UNITED STATES PATENT AND TRADEMARK OFFICE

Office Action Summary	Application No. 10/721,834	Applicant(s) NEUBAUER ET AL.	
	Examiner Keshia Gibson	Art Unit 3761

DETAILED ACTION

Fig. A: Examiner's mark-up of Merek's Fig. 6.

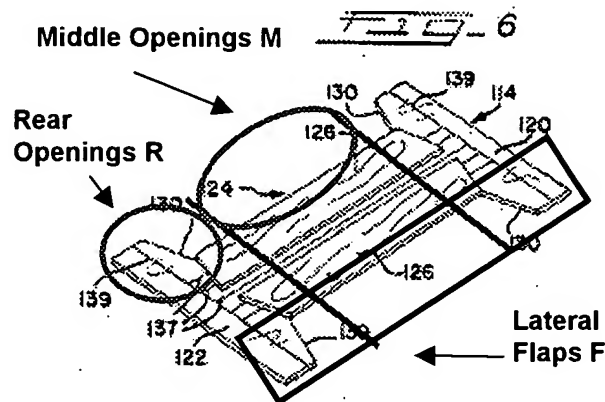
In regard to Claim 1, Mesek discloses an absorbent article 10, 110 comprising an outer cover 16, 116, a liner 12, 112, and an absorbent structure 14, 114. The absorbent structure further comprises a front portion 22, 122, a middle portion 24, 124, a rear portion 20, 120, a pair of opposing lateral flaps F, a pair of opposing middle openings (marked M in Fig. A below) spaced between the middle portion and the (outer portions of) the lateral flaps F, and a least one rear opening (marked R in Fig. A below) (Figs. 2, 4-6; column 7, lines 5-47). The folded portions 26/126 of lateral flaps F have been folded onto at least the middle region 24, 124 (Figs. 2 and 6). The middle portion 24, 124 has a width narrower than the width of the front portion 22, 122 due to the location of the pair of opposing middle openings M (see Figs. 2, 4-6, Fig. A). The folded portions

26, 126 of the flaps F create a two-layer structure in the middle portion 24, 124 (Figs. 2, 4-6; column 7, lines 27-38).

In regard to Claim 2, Mesek discloses that the middle portion 24, 124 includes a plurality of thicknesses, or layers, to provide increased absorptive capacity to the crotch region (column 7, lines 27-31). As further depicted in Fig. 6, the folded portions 26, 126 result in the absorbent structure 14, 114 being two layers thick. In Fig. 4, the folded portion result in the absorbent structure 14, 114 being three layers thick. From Figs. 2 and 5-6, it can be seen that the front 22, 122 and rear portions of the absorbent structure 14, 114 are only one layer thick. Therefore, Mesek discloses that the folded portions 26/126 create a basis weight (analogous to thickness) in the location of the middle portion 24, 124 that is at least twice the basis weight of the areas of the rear portion 20, 120.
